**Re: Request for a Conservation Commission Work Session  
Assessor's Map 207, Lot 13  
60 Pleasant Point Drive  
Altus Project No. 5138  
LU 23-180**

To: Kristin Duclos, DES Wetlands Permitting Specialist  
From: Jack McTigue, NH Professional Engineer, TFMoran, Inc.  
CC: Eben Lewis, DES Southeast Region Supervisor  
Date: August 28, 2024  
Re: Response to DES Request for More Information (RFMI) letter dated August 12, 2024 – DES Permit Application: 2023-03138

# TFMoran's Response to NHDES Request for More Information (RFMI) letter dated February 2, 2024.

## NHDES Wetlands Permit Application 2023-03138

TAX MAP 207 LOT 13  
**LIVING SHORELINE PLAN**  
**SHORELINE STABILIZATION**  
**60 PLEASANT POINT DRIVE, PORTSMOUTH NH**  
OWNED AND PREPARED FOR  
**120-0 WILD ROSE LANE, LLC**

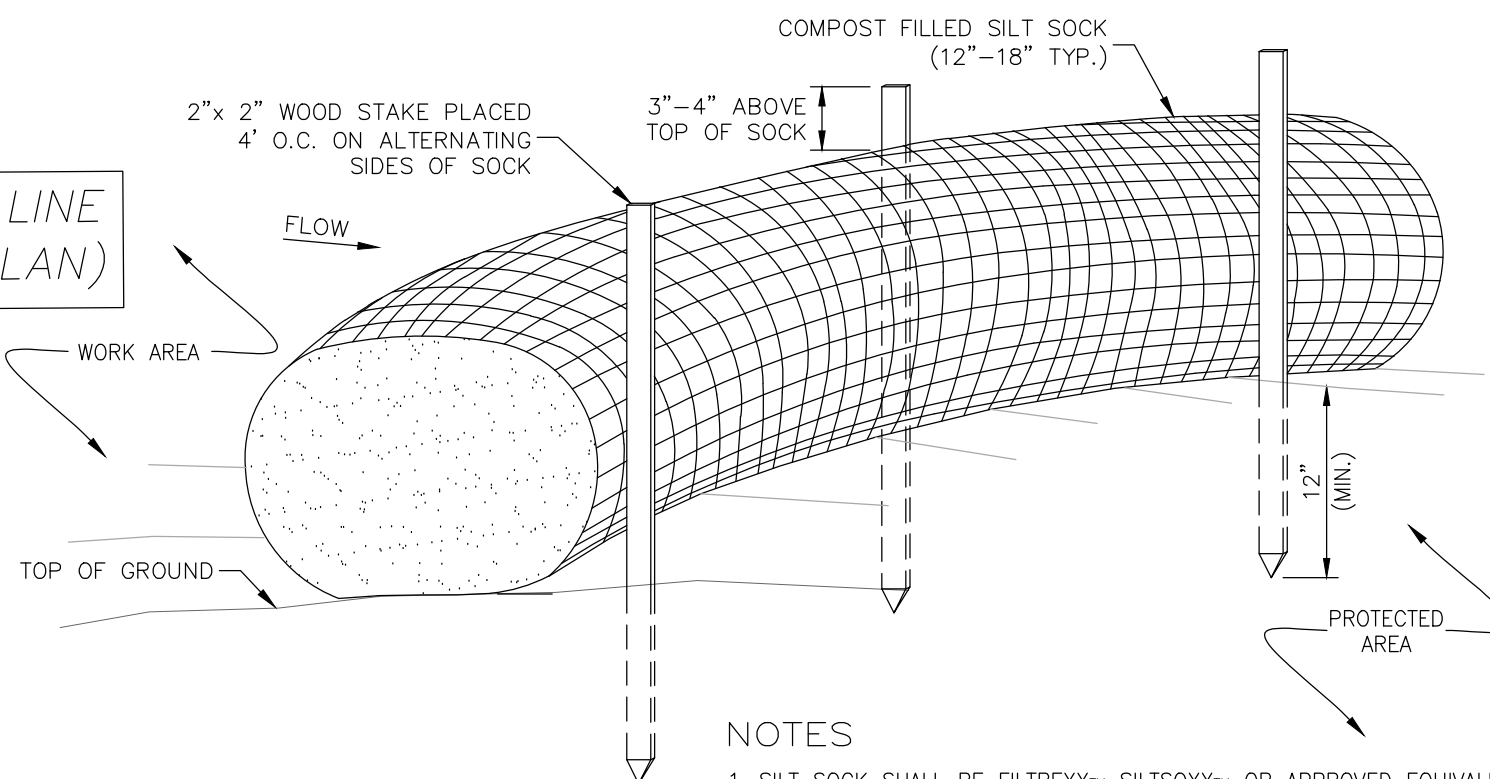
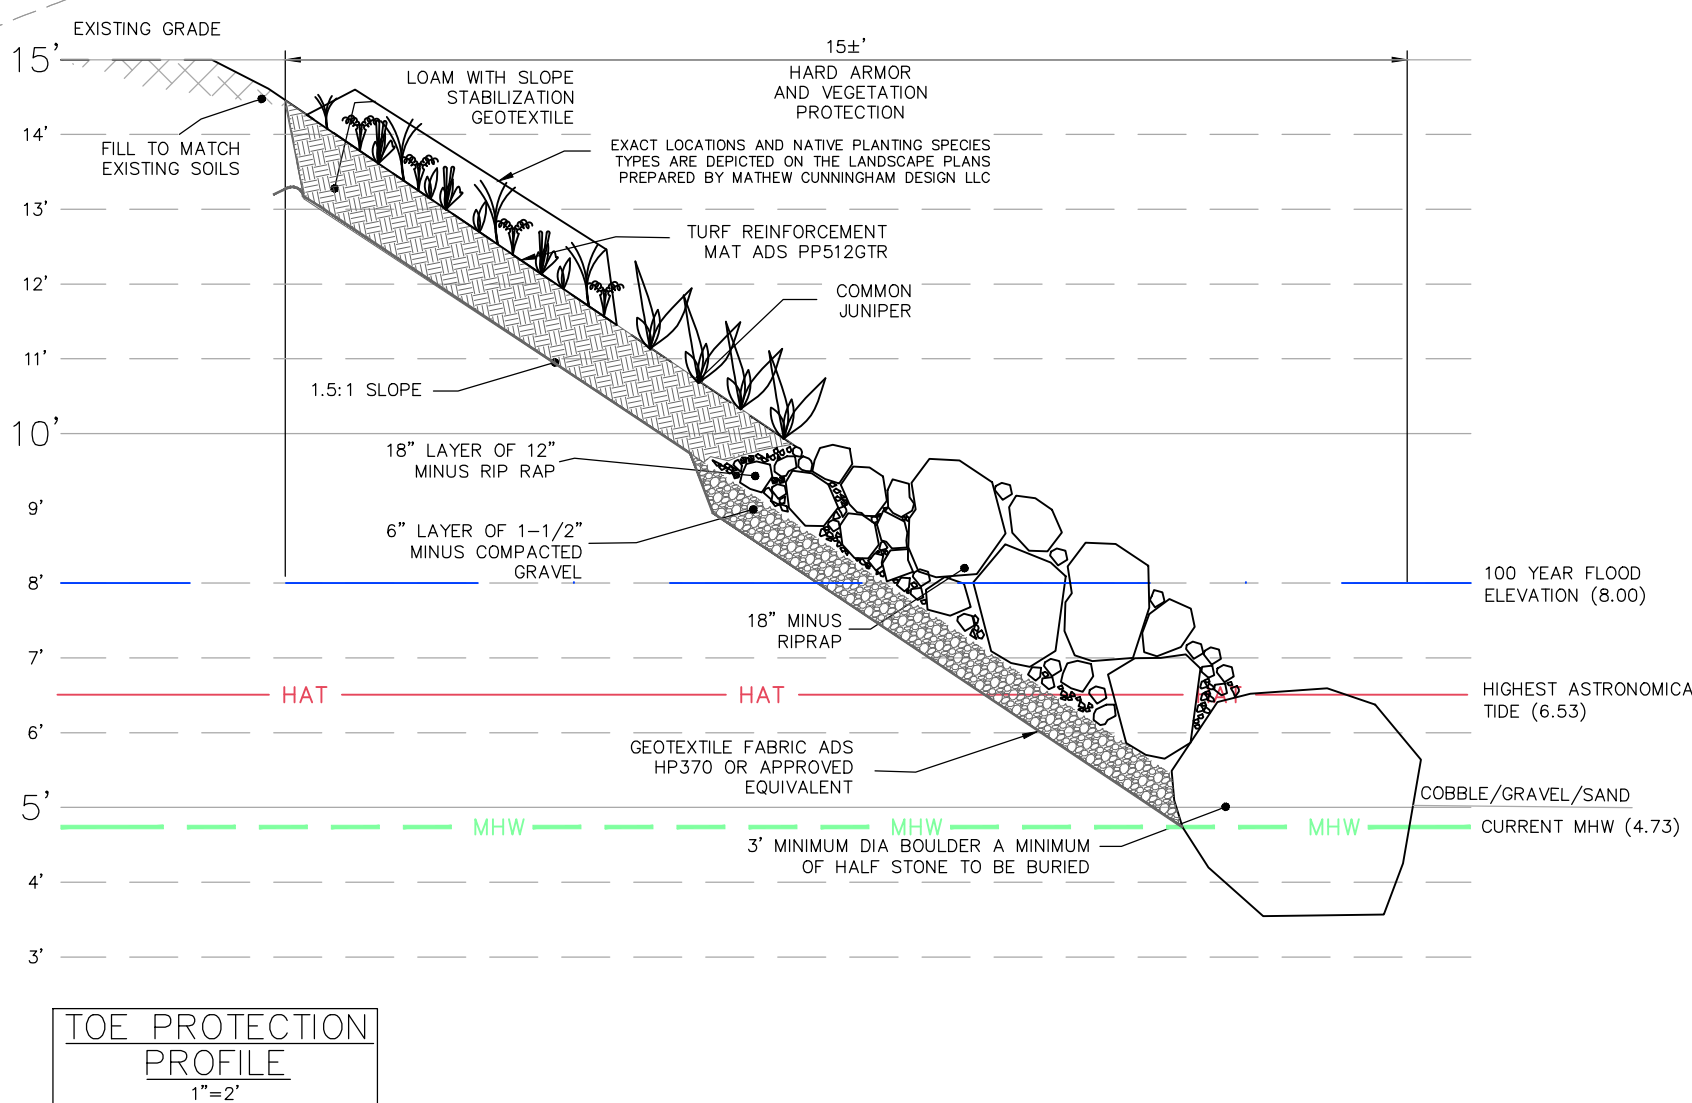
**6. Please revise the plans to show that the proposed living shoreline project will meet the all of the criteria listed in Env-Wt 609.05(b)(1) through (8), as required in accordance with Env-Wt 609.05(b), including but not limited to detailed plan views and cross sections of the existing slopes and proposed living shoreline treatments at representative stations along the length of the project; details regarding the proposed plantings; details regarding the methods for how all proposed bioengineered stabilization treatments will be securely anchored; etc.**

**Response:** We referenced the “Guidance for Considering the Use of Living Shorelines” when designing this Living Shoreline. The existing and proposed shoreline is relatively uniform in shape, and therefore, a single cross section of proposed Living Shoreline will suffice. As demonstrated on the Living Shoreline Details Plan included with the permit application, the proposed Living Shoreline meets all the criteria of **Env-609.05(b)**, specifically:

**Env-Wt 609.07(b)(5)** – A cross section of the Living Shoreline is depicted on Living Shoreline Plan included with this response.

**Figure 1-** Sea Level Affecting Marshes Model (SLAMM).

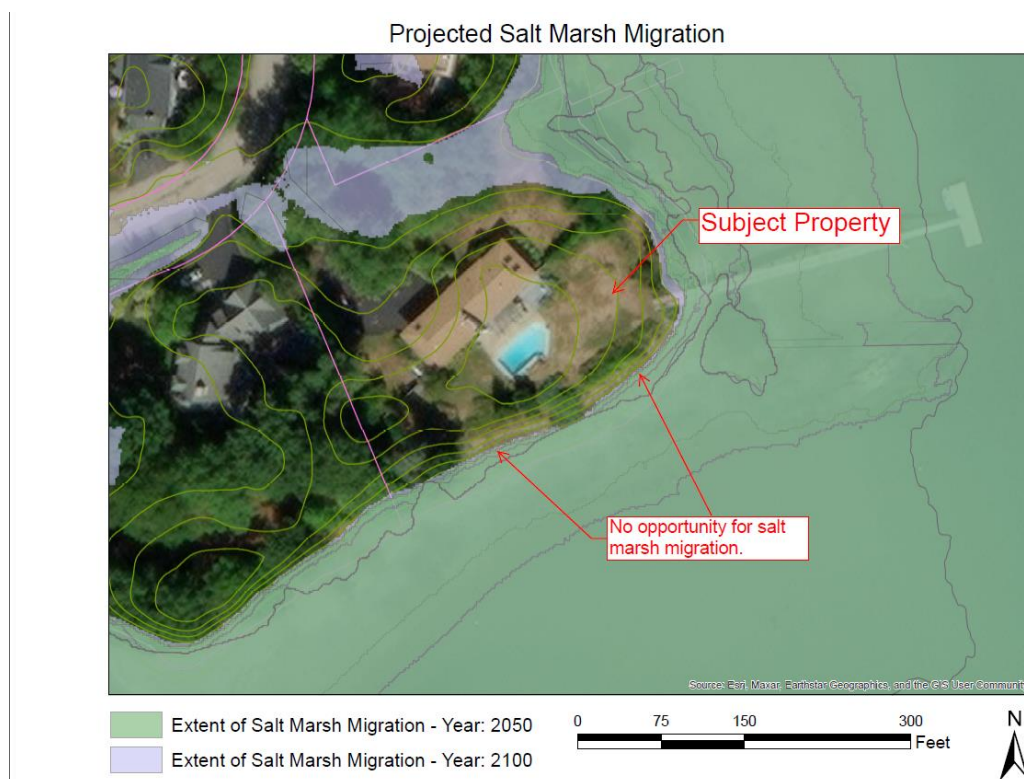
**5. Please provide documentation demonstrating how the proposed technique or combination of techniques used as part of the proposed tidal shoreline stabilization project addresses the criteria listed in Env-Wt 609.02(b)(1) through (7), as required in accordance with Env-Wt 609.02(b).**

**Env-Wt 609.02(b)(6)** – We have utilized the Sea Level Affecting Marshes Model (SLAMM) GIS data layers available on NH GRANIT. Given the topography of the site, the property *does not* lend itself well to future salt marsh migration. The proposed living shoreline does propose a wide variety of upland, salt tolerant native species – see **Figure 1** below.

**Figure 2** – Green, soft approach to constructing a Living Shoreline from the NOAA 2015 publication, “Guidance for Considering the Use of Living Shorelines.”

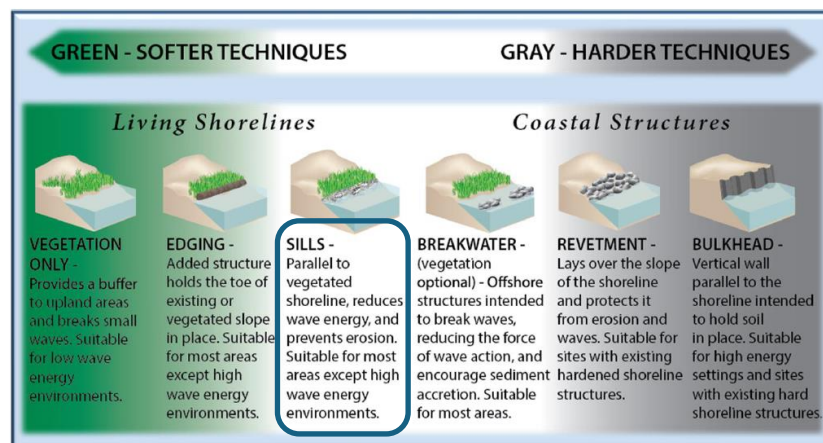
**8. Please provide documentation that the proposed living shoreline design plan has been reviewed relative to delineations of wetlands and stamped by a certified wetland scientist in accordance with "Guidance for Considering the Use of Living Shorelines", NOAA (2015) as required in accordance with Env-Wt 609.05(a).**

**Response:** We referenced the “Guidance for Considering the Use of Living Shorelines” when designing this Living Shoreline. As demonstrated on the Living Shoreline Details Plan included with the permit application, the proposed Living Shoreline is considered a “Green – Softer Technique” because only hard armor is proposed for sill materials for toe protection and greater resiliency for future, larger coastal storm events.
